## PLANNING REPORT

# Planning and Zoning Commission

Thursday, February 6, 2025

## Bright Road Reserve 24-135Z-PDP & 24-151PP

Site Plan

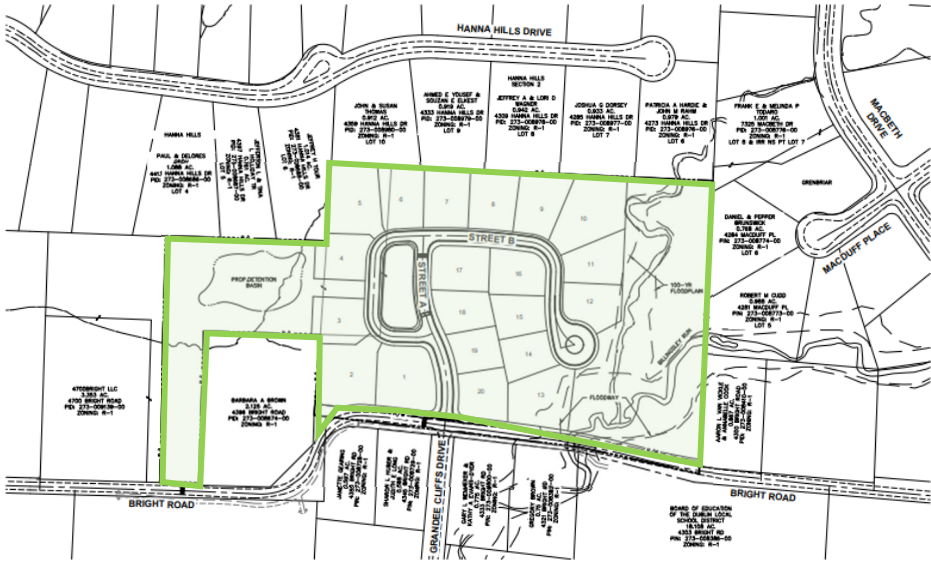
5-foot sidewalks, are proposed along the eastern side of Street A (Lots 17-20), and then the southern (lots 16 and 17) and western sides (lot 13-16) of Street B. The remainder of the neighborhood are proposed with ADA-accessible driveways to accommodate access to the sidewalk on the opposite side of the street and provide access to the Central Court. This design intentionally departs from the required standards to preserve green spaces and maintain the rural character of the proposal. However, per the recently adopted City standards, 6-foot sidewalks are required on both sides of the street with any development.

Staff has requested that the applicant provide factual details and implications of providing sidewalks on both side of the street and their impact on the proposed development. The applicant has provided a cross- section to show the required sidewalk on both sides and its

impact to the intended street character of the proposed development. However, no drawings are presented for staff to determine if the sidewalks would impact the development standards and the proposed layout and if they would deviate from the current layout and the intended theme of the proposal.

A diverse mix of naturalistically planted street trees is appropriate to the character of the site. The development text notes a 5-foot-wide tree lawn noted as standard throughout the development, but the drawings indicate 5.5-foot wide tree lawn, which tapers down to a narrower tree lawn, not adequate for a tree plantation. Code requires a minimum of 5-foot tree lawn, and Envision Dublin recommends an 8-foot tree lawn. The applicant must ensure that a uniform tree lawn is noted on the development plan and there are no discrepancies between the development text and the PDP drawings. Additionally, the landscape plan does not match the lot layout, and the submitted development drawings have discrepancies

- 1) The applicant provide a 6-foot wide sidewalk on both sides of streets in the subdivision and revise the development text accordingly, prior to City Council submittal.

- 4) The applicant provide a uniform tree lawn within the entire development without any discrepancies between the drawings prior to City Council submittal.

*Connections to City Networks*

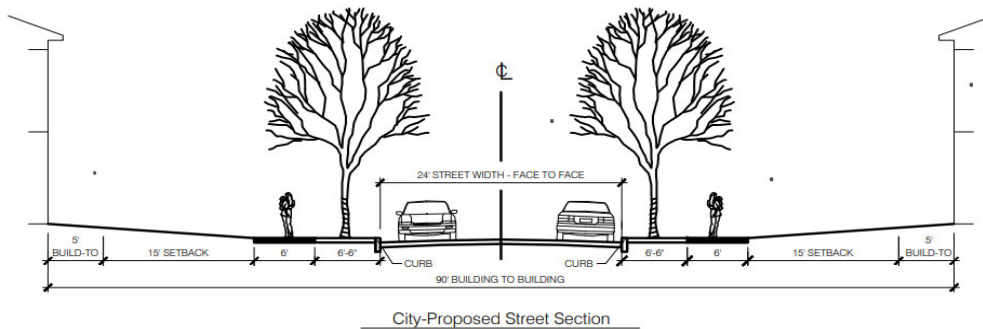
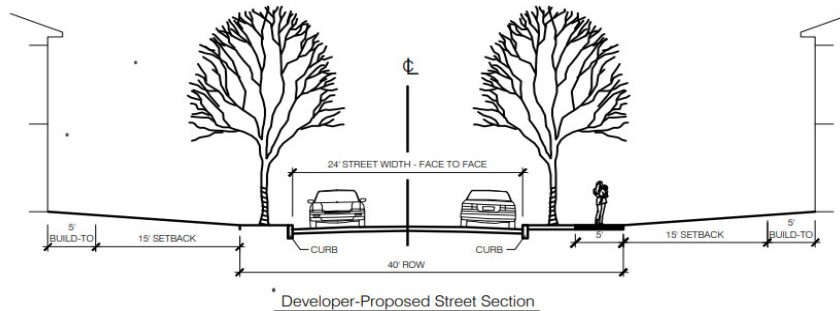
The proposed development is an infill project surrounded by single-family residential neighborhoods and is accessed only via Bright Road, which is a cul-de-sac. No additional road connections are planned for this development. A small portion of the site borders Bright Road across Ferris-Wright Park. To facilitate maintenance of the detention basin, a 10-foot wide shared use path will be provided as an access corridor from Bright Road. A crosswalk is provided at the south terminus of the shared use path, connecting the development to the existing Ferris Wright Park preservation area. The developer is also proposing an 8-foot wide specialty pavement path, approximately 140 feet long, to be constructed from Central Court to the east side of the detention basin, giving residents access to the West Wood and community open space. Staff recommends a continuous shared-use path from Bright Road to the neighborhood, ensuring pedestrian and ADA connectivity throughout the proposed development from the southwestern portion of the site. The shared use paths are recommended to be constructed per the City’s standards. If the applicant intends a specialty path to align with the development character, the maintenance responsibilities of the path should be described in the development plan.

- 2) The applicant provide a connected shared use path in Reserve A, per the City’s maintenance standards and revise the development text as required, prior to City Council submittal.
